CABINET MEMBER FOR ENVIRONMENT – 26 MARCH 2020

BURFORD – PROPOSED SPEED LIMIT REDUCTIONS AND SIGNALLED CROSSING ON A40 BY BURFORD SCHOOL

Report by Director of Community Operations

Background papers: Plan of proposed speed limits and puffin crossing

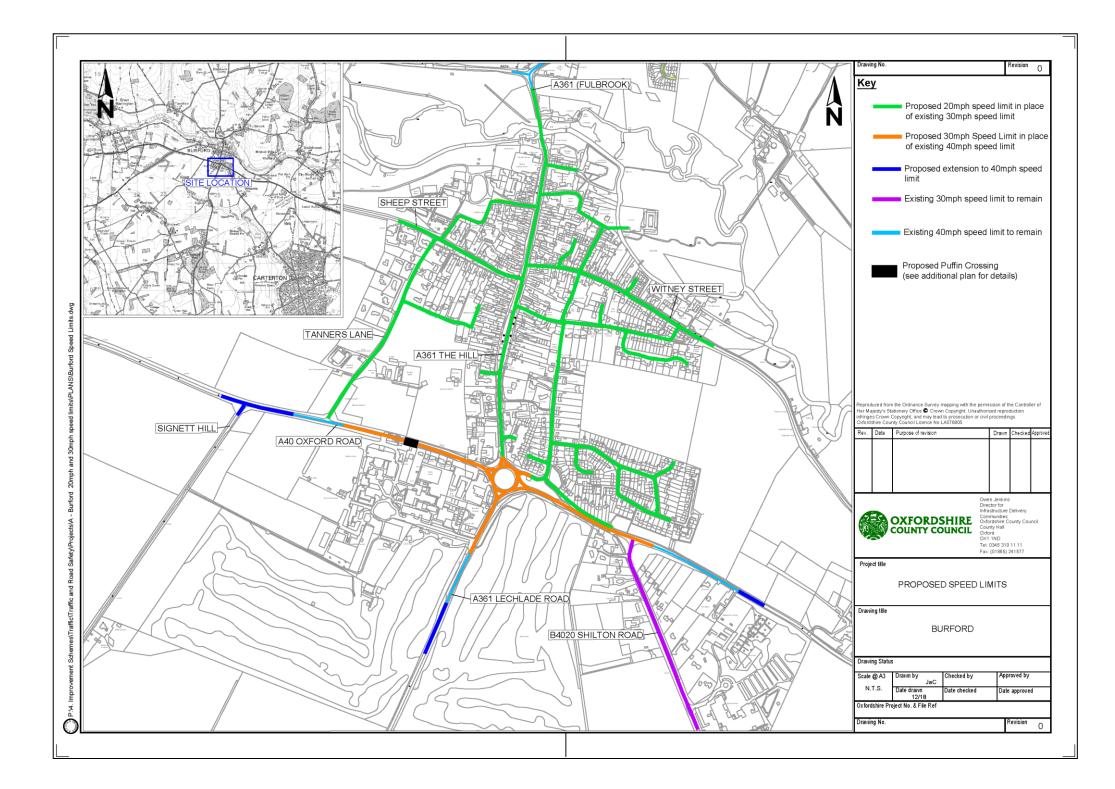
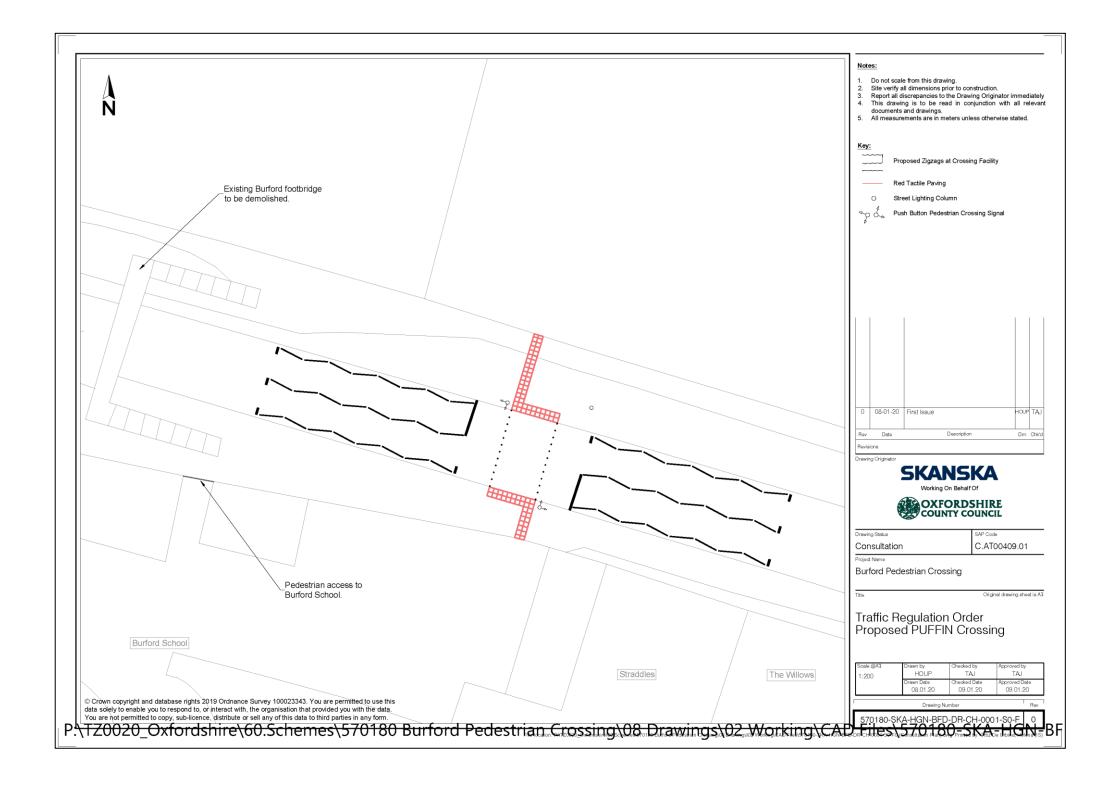
10. Thames Valley Police expressed an objection to the proposed speed limits. Specifically, they raised concerns that a 20mph speed limit on the A361 through Burford was not appropriate taking account of the 'A' road status and function as a through traffic route. They also expressed concerns over the proposed 30mph speed limits on the A40 and A361 as being unrealistic taking account of the existing speeds. They also expressed a concern that the

- replacement of the existing footbridge on the A40 by Burford School by a signalled crossing could be detrimental to road safety.
- 11. The local member expressed support for all the proposals with the exception of the proposed extension of the 40mph speed limits on the A40 and A361, on which no opinion was expressed.

- 12. West Oxfordshire District Council expressed support for all the proposals.
- 13. Mr John White, the Mayor of Burford expressed no opinion on the proposed speed limits but expressed a strong objection to the proposed signalled crossing primarily on the grounds of the safety of the many school students crossing here at the start and end of the school day and also the potential delays for traffic.

- 15. The objections to the proposed speed limits are noted. Thames Valley Police objections focussed on their appropriateness taking account of current speeds and the function of the A roads as major traffic routes. It is accepted that the proposed 30mph limits on the A40 and A361 are at the margins of compliance with the national guidance on setting local speed limits issued by the Department for Transport and the same is also the case for the 20mph speed limit on the A361 High Street, particularly in respect of the length south of the junction with Swan Lane. The objections received from other parties on the proposed speed limits were also largely on the grounds of need and appropriateness, although some responses cited the need for the 20mph speed limit to be extended further.

- 17. However, mindful that the length of the A361 south of the Swan Lane junction is a clearer departure from the national guidelines on setting speed limits, consideration could be given to amending the proposals for the 20mph limit to reduce its extent on the A361 The Hill.

- 18. The strong objections to the proposed puffin crossing on road safety and traffic delay grounds, including from the staff and governors of Burford School are noted and in view of this a further review of options will be carried out and presented to a future meeting. It should be noted that while the speed limit reduction on the A40 would be highly advisable in the event of a signalled

1. The Cabinet Member for Environment is RECOMMENDED to approve the proposed reduced speed limits at Burford as advertised but with consideration being given to reducing the extent of the proposed 20mph speed limit on the A361 The Hill, but to defer a decision on the installation of a puffin crossing (a signalled crossing for pedestrians) on the A40 by Burford School in place of the existing footbridge.
